List of glyphs in questions

reference

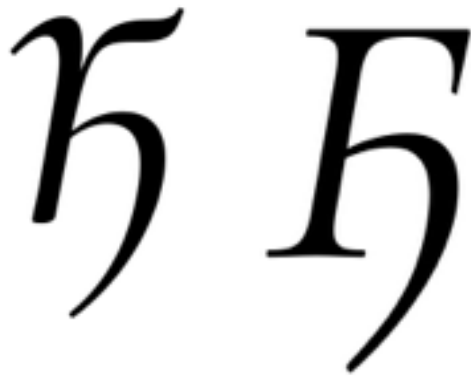
Ʒ — see reference
correlate with Ʒ (U+045F)
